2017SSH028 – 49-57 GERRALE STREET, CRONULLA

DA17/0885

ASSESSMENT REPORT APPENDICES

DRAFT CONDITIONS OF CONSENT
Development Application No. 17/0885

Room Legend

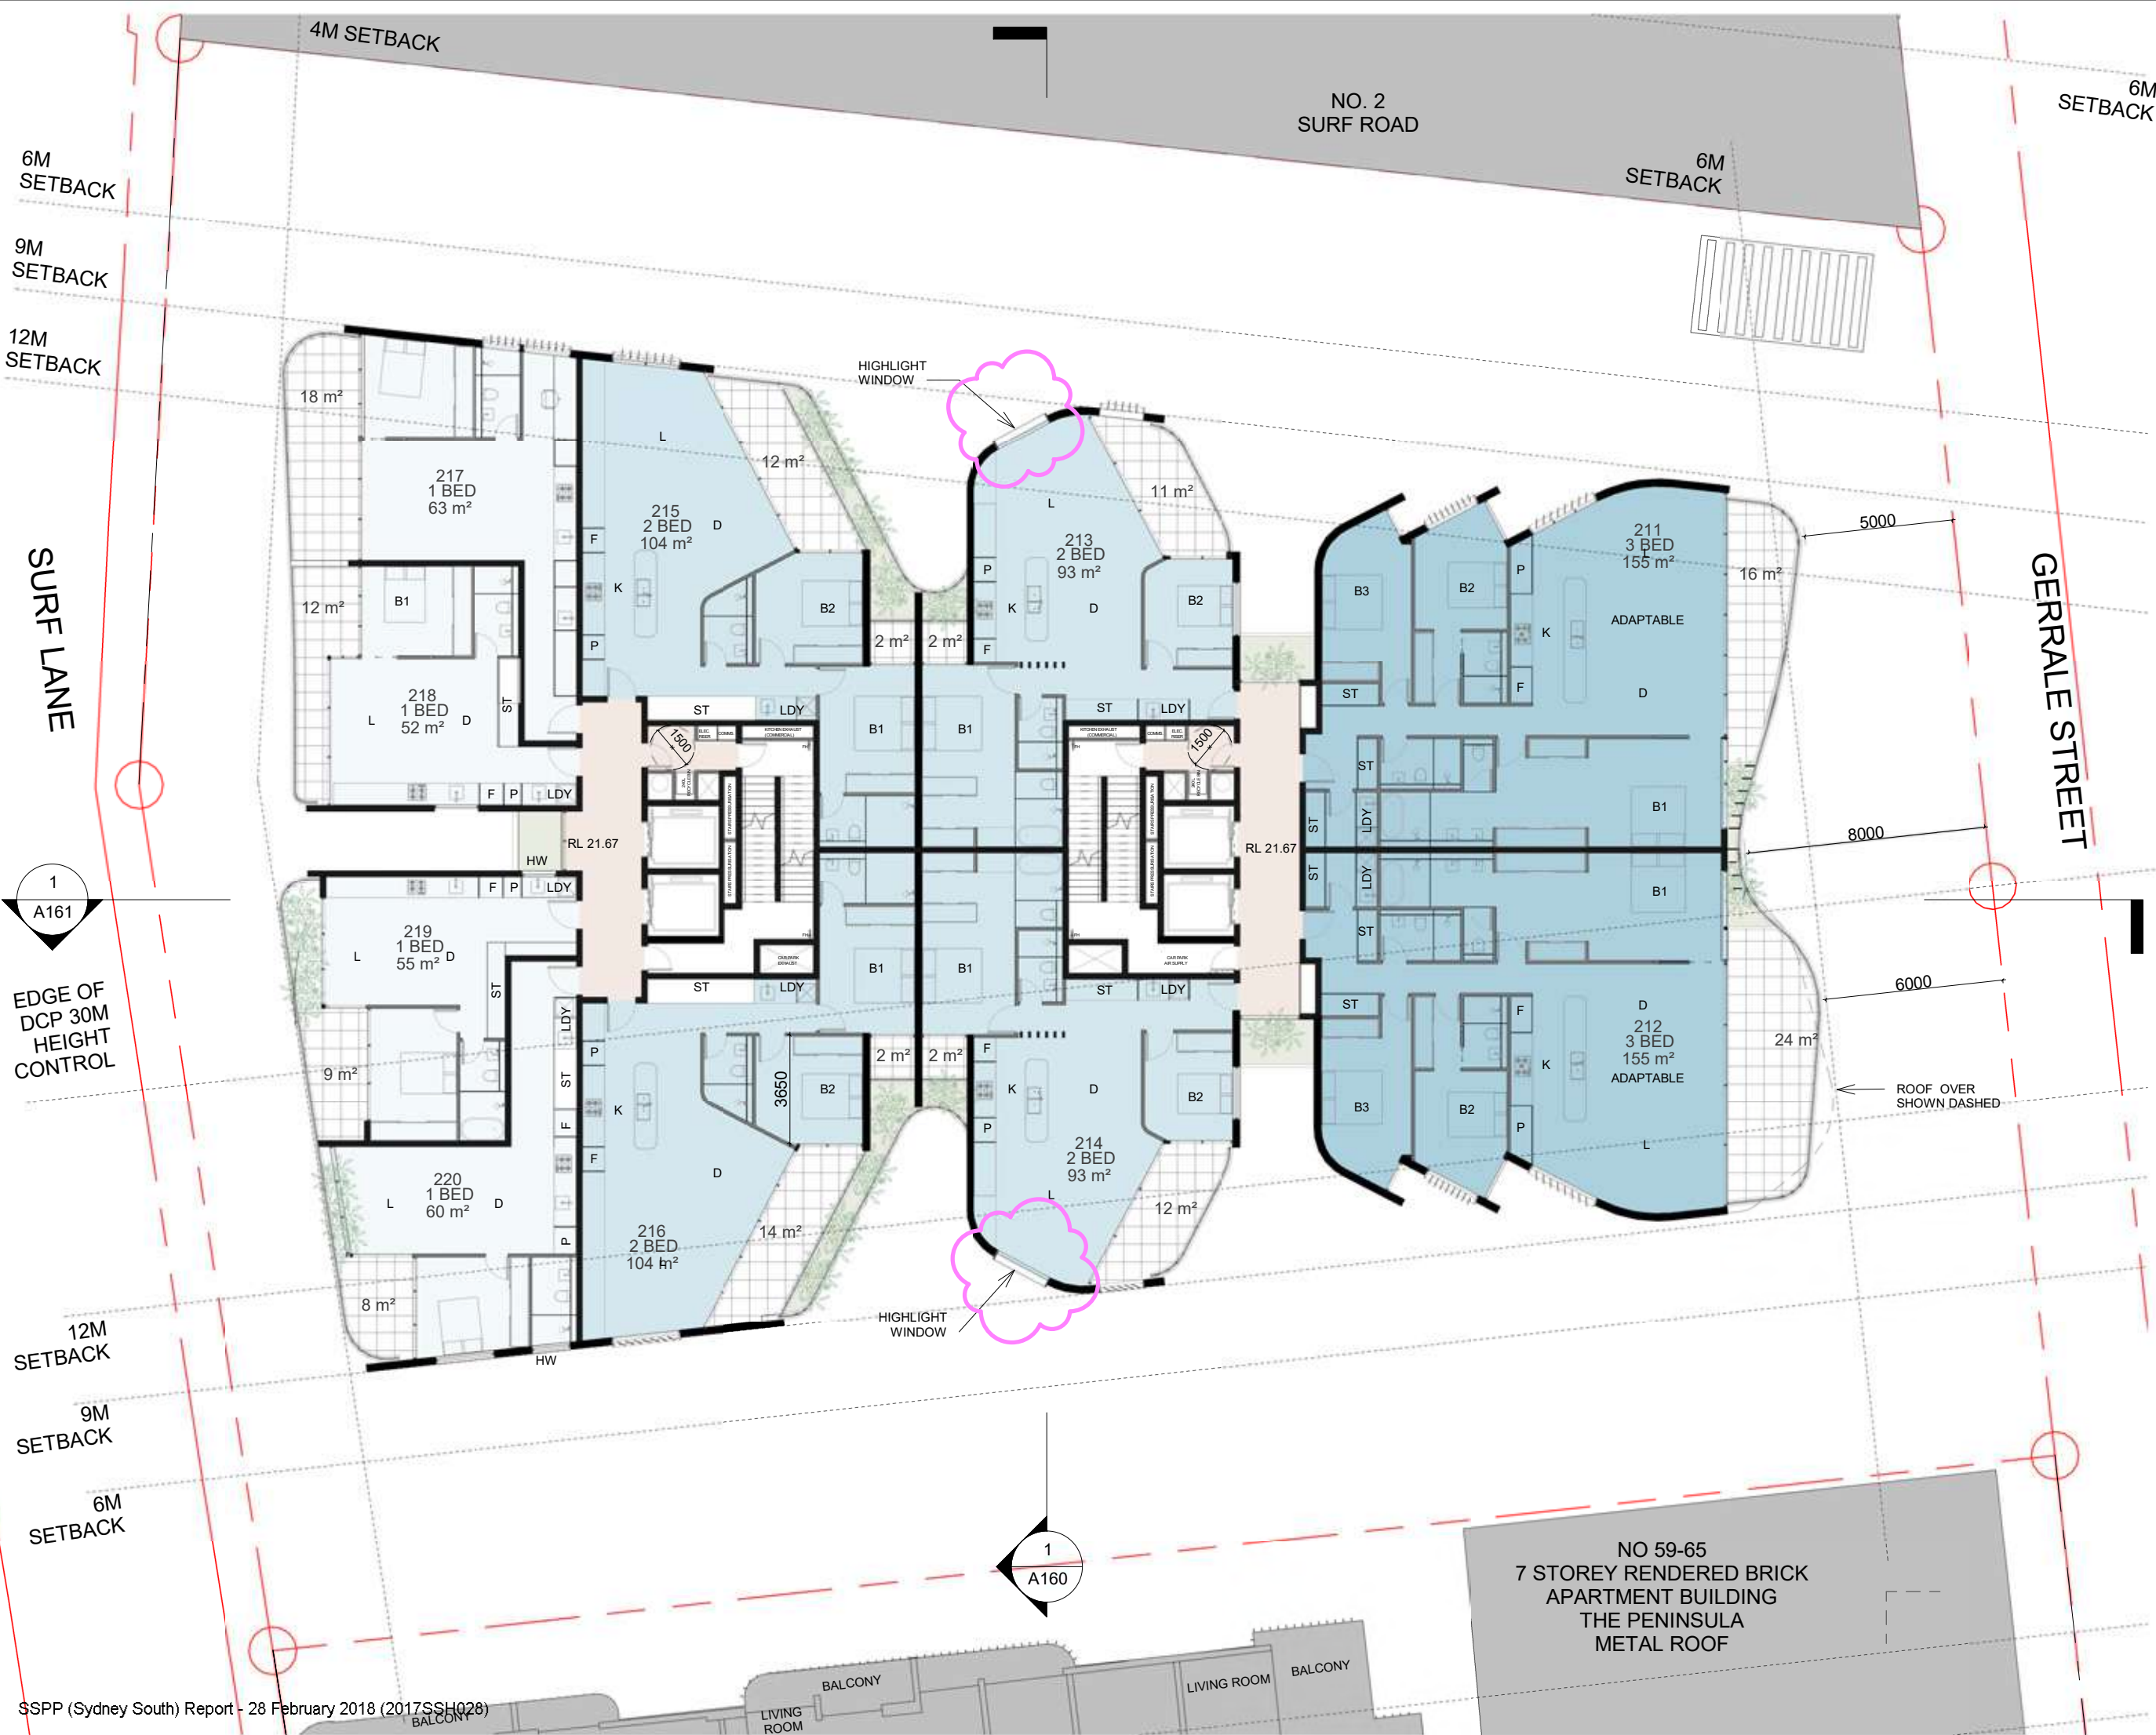
- ii) Unobstructed internal access must be provided from the Gerrale Street tenancies to the commercial garbage room and Surf Lane loading area. This will require the deletion of the wall shown on Ground Floor Plan A100 Rev K;

LANDSCAPE PLAN GROUND FLOOR + PUBLIC DOMAIN

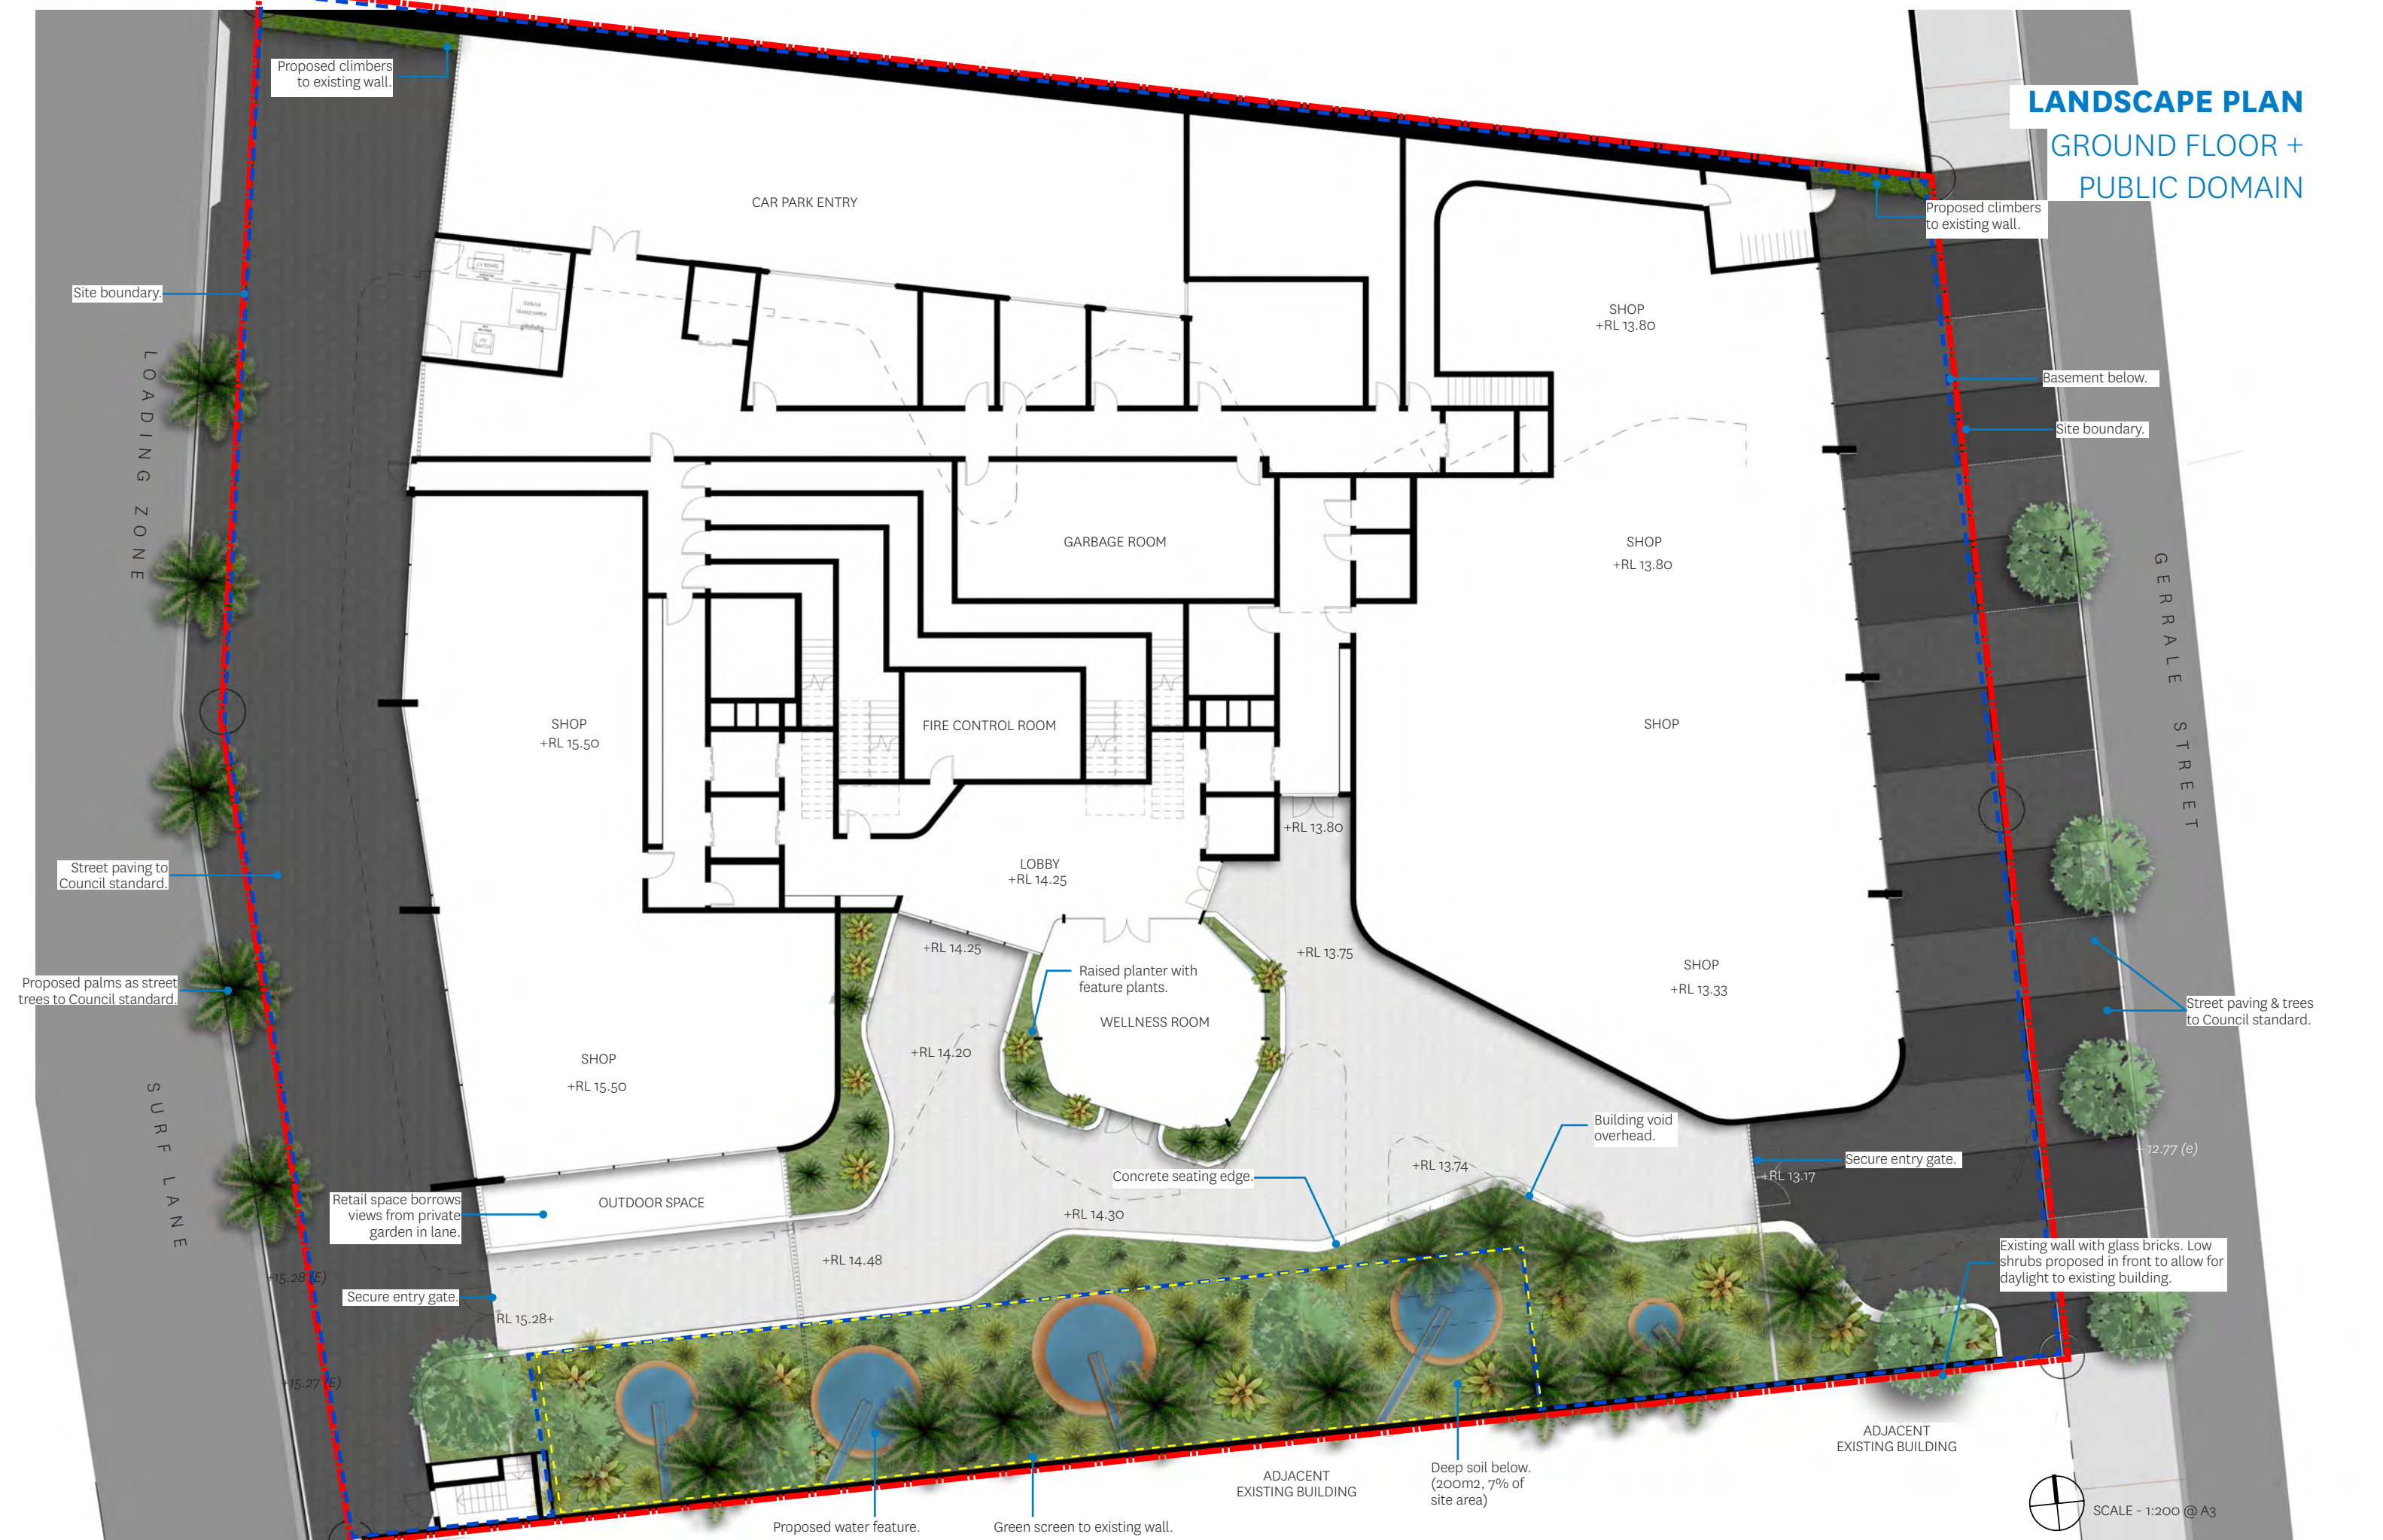
- v) In Surf Lane relocate the 5 x *Livistona australis* (Cabbage Tree palms) shown on the Landscape Plan from the kerb to within the site. The tree trunk must be wholly inside the property boundary. Each palm tree must be provided with a tree cell, drainage, soil preparation, tree guard, watering, grating and/or mulching to match the Gerrale Street frontage as directed by Council.

- vi) Within the ground floor palm plantings include an additional 3 x *Cupaniopsis anarcardioides* (Tuckeroo) and 5x *Synoum glandulosum* (Bastard Rosewood) to help reduce wind tunnelling in the side passage.
